THE SHERWIN-WILLIAMS COMPANY Environmental, Health & Regulatory Services 101 Prospect Avenue NW Cleveland, Ohio 44115-1075 Facsimile: (216) 566-2730

RE: Sherwin-Williams Gibbsboro Sites

Use of XRF Analyses During Remedial Investigation of Hilliard Creek

Transect HCT 37 – Alternate Transect due to Access Issues

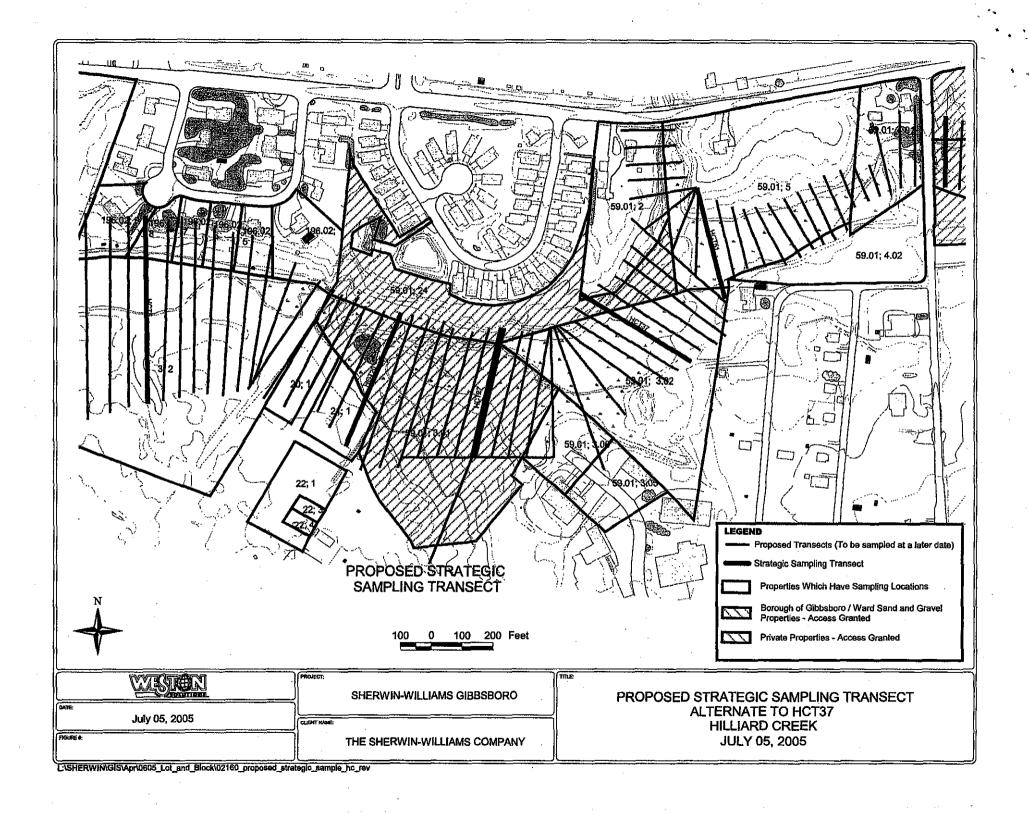
Sherwin-Williams has not been able to gain access to Block 59.01/Lot 3.02, which is owned by the Gibbsboro Sewerage Corp. An email forwarded to EPA on June 22, 2005 summarizes our efforts-to-date to gain access. As a result of not gaining access, Weston is unable to collect samples along the southern two-thirds of Transect HCT 37.

Samples have been collected in the northern portion of the transect, which is located within property owned by the Borough of Gibbsboro (sample locations can be viewed with ArcIMS on TeamLink using the soil sample query), however it does not appear likely that access to the southern portion will be achieved without considerable legal effort nor in a reasonable time-frame.

Based on this lack of access, Weston has requested approval to select another transect further downstream along Hilliard Creek to replace HCT 37. On June 16, 2005, Sally Jones (Weston), and Ray Klimcsak (EPA) conducted a site visit to inspect this location and identify a suitable replacement transect. During the weekly conference call with EPA on June 20, 2005, EPA agreed to select another transect for the Strategic Sampling Event.

Based on these meetings and discussions, it is proposed to designate Transect HCT 27 as an alternate/replacement for the southern portion of Transect HCT 37. Attached is a site map that identifies the location of Transect HCT 27 that will be added to the Strategic Sampling Event.

Transect WST 13 – Dump Site

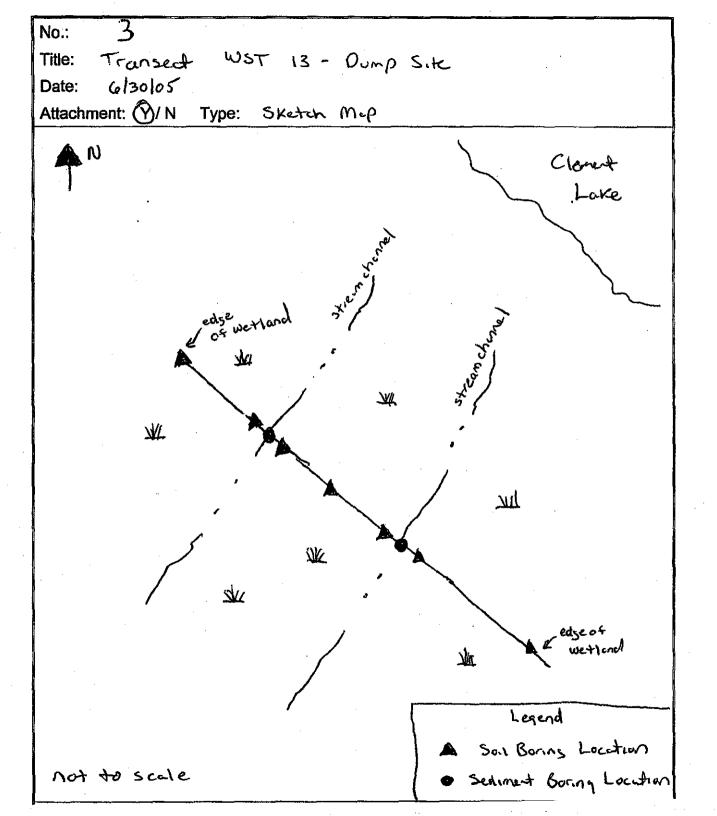
Transect WST 13 is located along White Sand Branch within the fenced area of the Dump Site. The sampling approach for this transect required clarification and possible modification from the 2003 approved Work Plan because Weston encountered unique field conditions.

Transect WST 13 cuts across an area that is at a low elevation, compared to the surrounding area, and is generally very wet. The sampling teams observed two stream channels bisecting this transect. The presence of two channels is consistent with historic and current topographic maps of the area. The unique feature of this area, compared to other areas in Hilliard Creek, is that on either side of the channels the soils are very saturated with occasional ponding. This may be attributable to a high water table or temporary back-flooding. The field teams requested guidance on whether sediment or soil sampling protocols should be followed on either side of the channels.

Mary Lou Capichioni (Sherwin-Williams), Sally Jones and Patrick Austin (both Weston), Richard Funk (Tetra Tech) and Ray Klimcsak (EPA) conducted a site visit on Thursday, June 30, 2005, to inspect the transect area (see attached sketch map). Two stream channels were observed, each less than 5 feet in width. Mr. Klimcsak (EPA) agreed to a modification to the scope of work presented in the 2003 approved Work Plan due to the unique field conditions encountered at this transect. Samples will be collected along transect WST 13 in accordance with the following protocol:

Based on the observed 5-foot width of the stream channels, one sediment boring will be located in each stream channel along the path of the transect and the sediment sampling approach from the 2003 Work Plan will be followed. This approach includes collecting two samples from each soil boring for full TAL/TCL analysis; 0-6 and 18-24 inches bgs.

Seven soil borings will be located along the remaining portions of the transect, as per the attached sketch map. Soil borings will be placed in the following areas:

- Five feet from each side of the stream channels (4 borings):
- One in the mid-center between each stream channel; and
- One boring at each end of the transect located at the edge of wetland.

HCT 139 - Hilliard Creek

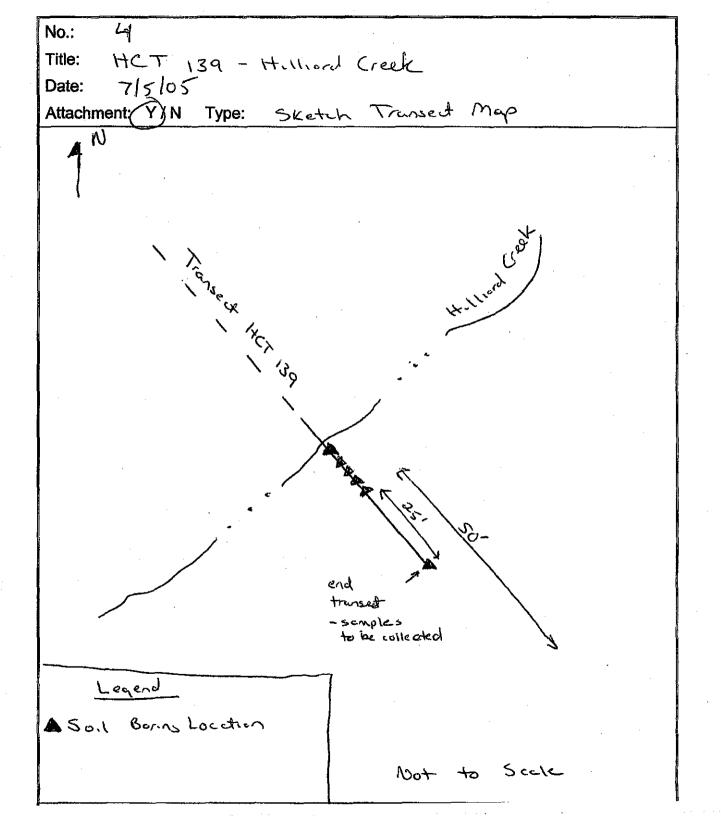
On June 30, 2005, Mary Lou Capichioni (Sherwin-Williams), Sally Jones, Patrick Austin and Catfish Brownell (all of Weston), Richard Funk (Tetra Tech) and Ray Klimcsak (EPA) conducted a site visit at Transect HCT 139 to address soil boring location questions raised by the soil sampling field team. As per the 2003 approved Work Plan, the soil sampling field team established boring locations every five feet from the stream channel embankment for the first 20 feet. The team raised questions when attempting to locate the next boring along the southern portion of the transect which, as per the Work Plan, was to be located 50 feet from the last boring located 20 feet from the stream channel embankment. In this situation, the transect ended approximately 25 feet from the last soil boring location, less than the 50-foot sampling distance required in the Work Plan. In addition, the end of the transect appeared to be outside of the floodplain. The team was unsure of where, or if, an additional boring location was required.

During the June 30, 2005 site visit, Sherwin-Williams agreed to make a proposal to EPA. Sherwin-Williams proposes to locate one additional boring along the southern end of HCT 139, at the transect's terminus. The sampling will be conducted in accordance with Addendum #1 of the 2003 approved Work Plan. It was understood by EPA and Sherwin-Williams that this location was apparently outside of the floodplain and would represent upland conditions. A sketch map is attached.

Shallow Groundwater Well Locations - Dump Site

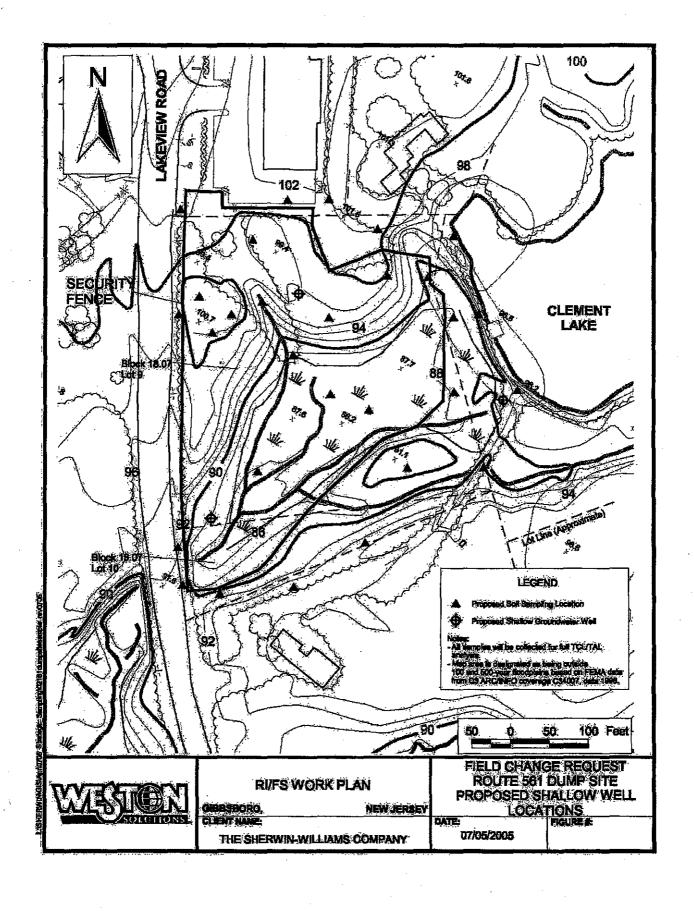
As per previous discussions and correspondence between EPA and Sherwin-Williams, there are three shallow groundwater monitoring wells proposed for the Dump Site.

Mary Lou Capichioni (Sherwin-Williams), Sally Jones and Patrick Austin (both Weston), Richard Funk (Tetra Tech) and Ray Klimcsak (EPA) conducted a site visit on June 30, 2005, to inspect the proposed locations. At that time, Sherwin-Williams and EPA agreed to the locations depicted on the attached figure.

The downgradient well was relocated approximately 100 feet to the north per EPA's request. The upgradient well was relocated approximately 15 feet to the northwest in an area with better access.

EXISTING AND PROPOSED CONDITIONS AT BWL20 AND BWL21 AT BRIDGEWOOD LAKE, JULY 21, 2005

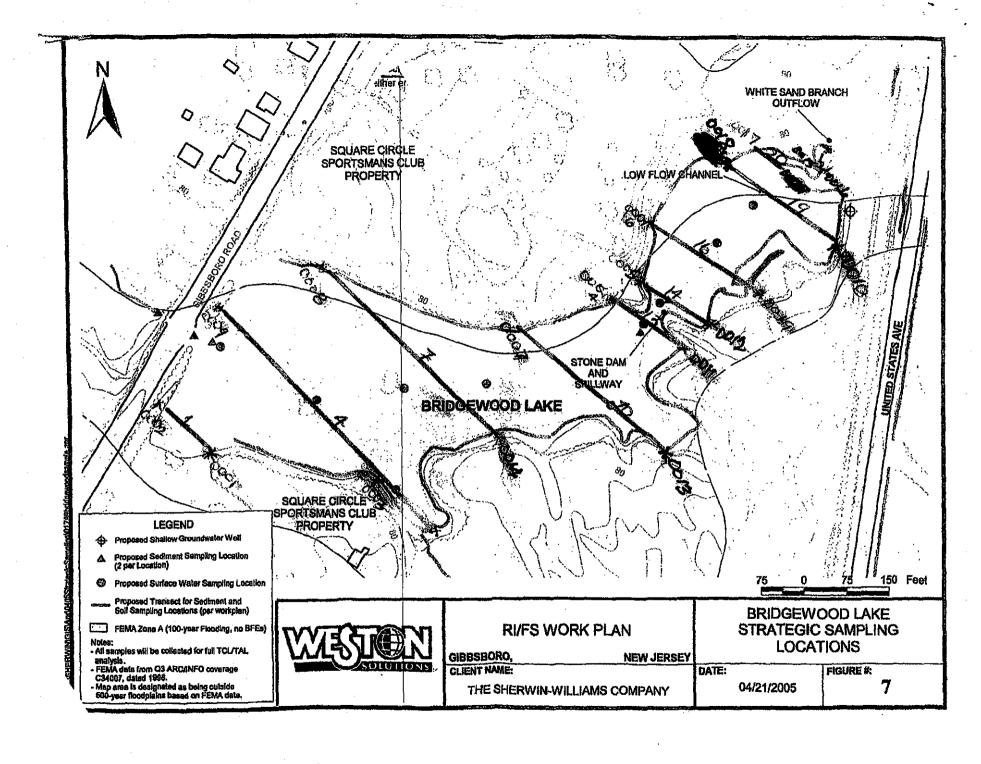
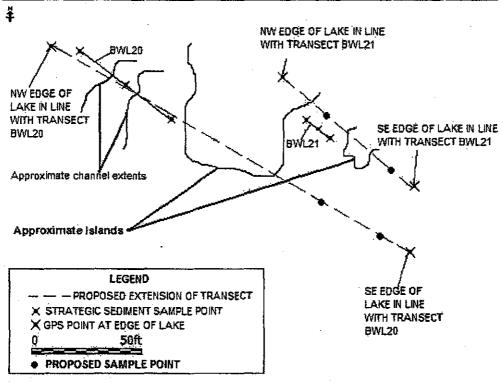
While sampling the upper section (eastern lobe) of Bridgewood Lake along the Railroad Track Site and United States Avenue, a discrepancy was noted regarding the length of the transects and their position relative to the location of the islands and width of the lake (see attached maps).

Transect BWL-20 is located in the northwest section of the upper lake and extends from the NW shoreline of the lake to the island in the center. This transect traverses the stream entering from White Sand Branch in the adjacent Burn Site. remaining portion of this transect that crosses the SE section of Bridgewood Lake that is not part of the original Transect BWL-20, but would be located on the extension of that transect.

Sediment samples have been collected along the original Transect BWL-20 (Location IDs BWDD-0047 to 0049) and a soil sample was collected on the northwest shoreline (Location ID BWSB-0017). The southeast soil sample location, as depicted on the original transect, was located on the island and was not accessible to the soil

Likewise, there is a similar situation with Transect BWL-21, as the original transect length does not span the width of the lake. This transect is located in a shallow backwater type area on the southeast shoreline.

Based on the field conditions. Sherwin-Williams proposes to collect additional sediment samples along the extension of Transect BWL-20 in the SE section of Bridgewood Lake. It is proposed to collect two additional samples along this transect; one adjacent to the SE shoreline and the other 50 feet from that location in the vicinity of the island shoreline.

Regarding the soil sample location, Sherwin-Williams proposes to relocate this sample from the original transect location on the inaccessible island to the SE shoreline along the extension of the transect.

Sediment samples have not been collected in that area as yet, and it is proposed to collect two samples along this transect, one on each side of the small island that splits that transect.

Both soil sample locations were collected along the original location of the transect (Location IDs BWSB-0015 and 0016), and it is proposed to collect one additional sample on the SE shoreline along the extension of the transect.

Burn Site – Delineation Soil Boring Locations

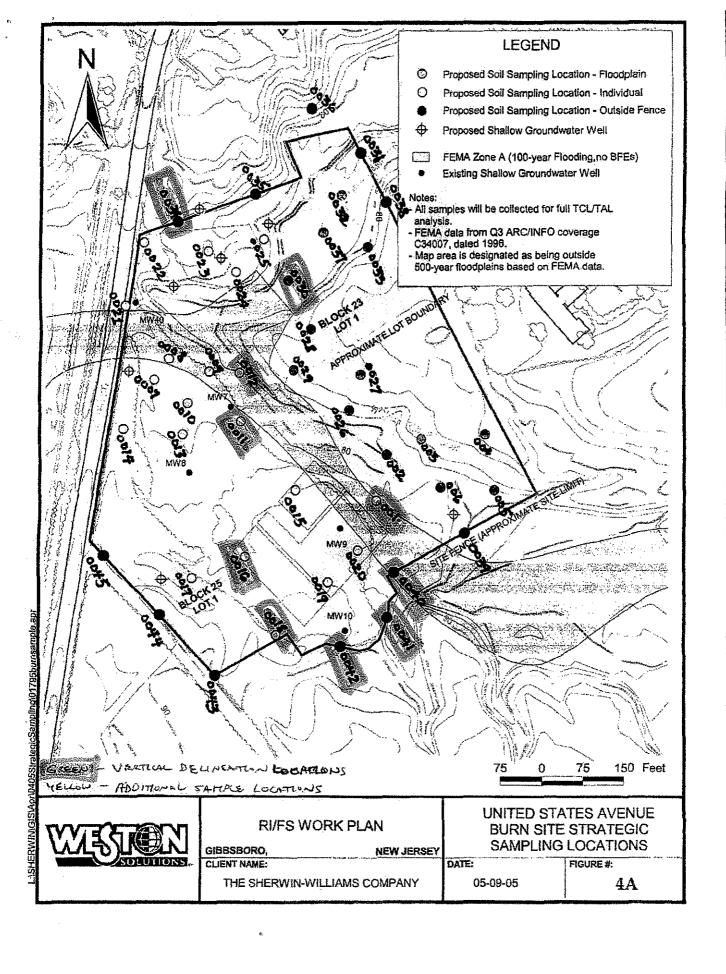
Upon review of the field observations noted during the soil boring program conducted at the Burn Site, it was determined that there are sample locations that merit additional vertical delineation and/or sample collection at particular depths. On August 29, 2005, Mary Lou Capichioni (Sherwin-Williams), Hank Martin (ELM), Sally Jones and Art Fischer (both of Weston), Ray Klimcsak (EPA) and Lynn Arabia (TetraTech/EPA oversight) attended a site meeting to discuss these observations.

During the investigation, if there was no evidence of contamination above or through the water table interface, the soil boring was abandoned and no samples were collected (in accordance with the November 2003 Work Plan). Upon further review of the field notes from these locations, it was observed that the above-mentioned borings (those terminated at the water table) are in close proximity to other borings that showed evidence of contamination above and through the water table interface. The borings that exhibited evidence of contamination (discoloration, staining, elevated PID readings) were advanced to depth (typically 10-12 feet bgs) until the contamination was delineated and a 'clean' sample was collected below the contaminated interval.

Upon further review of the field notes, it was determined that there was evidence of contamination (discoloration, staining, elevated PID readings) noted at particular boring locations that merited further investigation and sample collection.

Due to the fact that these terminated borings are in close proximity to borings where contamination was noted at depth, Sherwin-Williams is proposing to advance these borings to depth (typically 10-12 feet bgs) to inspect and field screen the soils for evidence of contamination. If there is no evidence of contamination, this fact will be noted and no additional samples will be collected. If there is evidence of contamination, Sherwin-Williams will delineate and collect samples of the contaminated interval as well as the underlying 'clean' interval for full TAL/TCL analytical parameters.

The following sample locations at the Burn Site (BSSB) will be inspected and fieldscreened for evidence of contamination to confirm that vertical delineation has been achieved: 0001, 0011, 0012, 0016, 0018, 0030, 0034, 0040, 0041 and 0042.

The following sample locations at the Burn Site (BSSB) will be inspected and fieldscreened for evidence of contamination to confirm that vertical delineation has been achieved. Additional samples will be collected as necessary.

0017 – Staining noted at 2.0 to 2.5 ft. bgs, PID readings were 0.0. – Depth to water was determined to be 5.0 ft. bgs. The boring was completed to 6.0 ft. bgs. No other staining was noted other than at 2.0 to 2.5 ft. interval mentioned above. Samples were collected at 0.0 to 2.0 ft. bgs interval (AA-AE); 3.0 to 3.5 ft. bgs (AG-AH); and 4.5 to 5.0 ft. bgs (AJ-AK). Additional sample to be collected at 2.0 to 2.5 ft. interval (AE-AF) for full TAL/TCL analytical parameters.

0019 – Staining and discoloration noted from 0.0 to 6.0 ft. bgs, PID readings were 0.0. – Depth to water was determined to be 4.0 ft. bgs. No staining or discoloration noted below 6.0 ft. bgs. The boring was completed to 9.0 ft. bgs. Samples were collected at 0.0 to 2.0 ft. bgs interval (AA-AE) and 3.5 to 4.0 ft. bgs (AH-AI). Additional samples to be collected within the stained interval below the water table and within the underlying 'clean' interval for full TAL/TCL analytical parameters.

0020 - Staining and discoloration noted from 0.0 to 3.0 ft. bgs (PID readings = 60); and from 5.0 to 6.0 ft. bgs (PID readings = 400). Elevated PID readings (600) were also noted in the 6.0 to 9.0 ft. bgs interval. – Depth to water was determined to be 6.0 ft. bgs. The boring was terminated at 9.0 ft. bgs due to refusal. A total of 3 locations were attempted, and refusal was encountered at 9.0 ft. bgs at each location. Samples were collected at 0.0 to 2.0 ft. bgs interval (AA-AE); 3.0 to 3.5 ft. bgs (AG-AH); and 5.5 to 6.0 ft. bgs (AL-AM). Additional sample to be collected within the 6.0 to 9.0 ft. bgs interval for full TAL/TCL analytical parameters. An additional sample within the underlying 'clean' interval will also be collected if the driller is able to advance the boring past the refusal depth of 9.0 ft. bgs.

Background Sampling Event - Relocation of Clement Lake Proposed

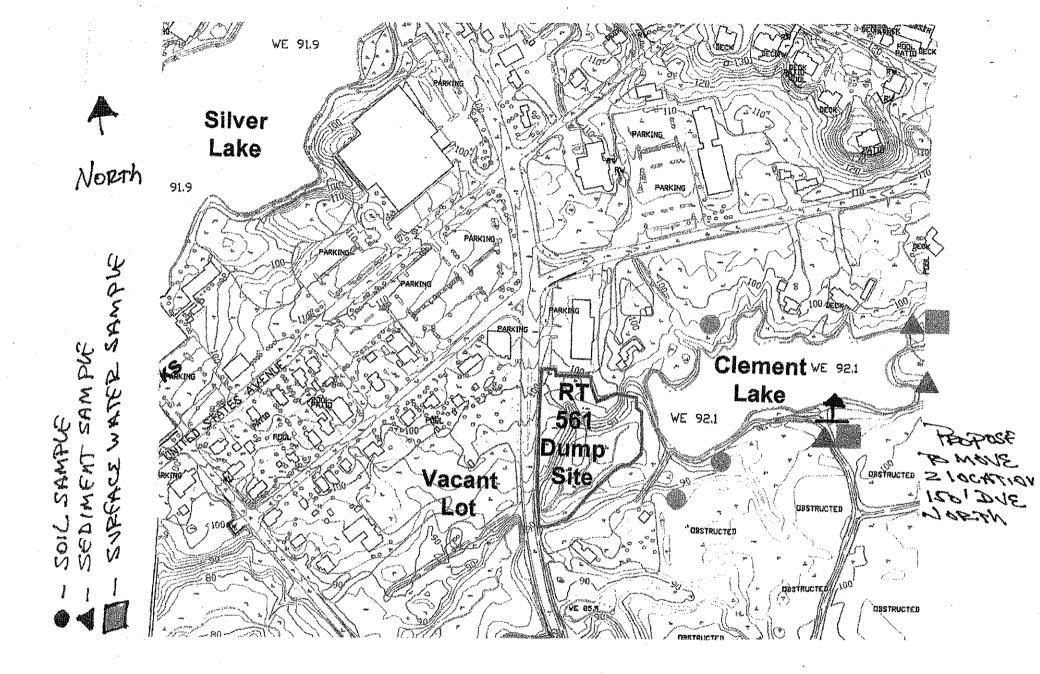
During the layout of the proposed background sample locations at Clement Lake, a field reconnaissance was performed by Weston field personnel on September 1, 2005. At this time it was observed that the southern-most proposed sediment and surface water sample locations (respectively identified by a red triangle and orange square) along the perimeter of Clement Lake, corresponded to a dirt road, instead of a tributary entering Clement Lake. As such, sampling for the proposed sampling media from these locations would not be possible.

In response to these field conditions, Sherwin-Williams proposes to relocate this paired sediment/surface water sample location approximately 150 feet north to the southern shoreline as identified on the Proposed Background Sample Location Map.
